### Subject of the modification

All PTX FM transmitter modules sold before May 30, 2009.

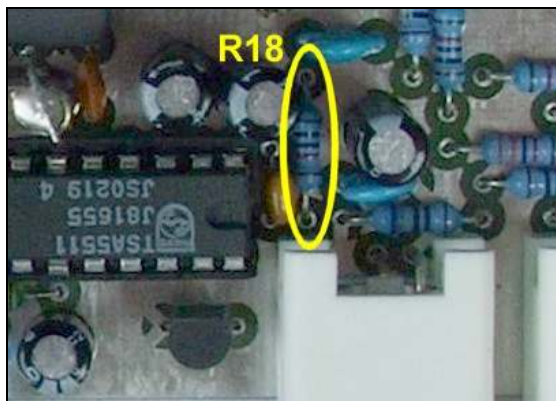
Flat PLL response on the lowest audio frequencies down to 4 Hz.

1. Turn off the unit and disconnect all cables.
2. Locate R18 resistor (10k) on the board, near the TSA5511 IC and RDS/SCA input connector.
3. Unsolder the R18 and place new resistor with a value of 3k3.  
OR  
Bypass the R18 with an additional resistor with a value of 4k7.
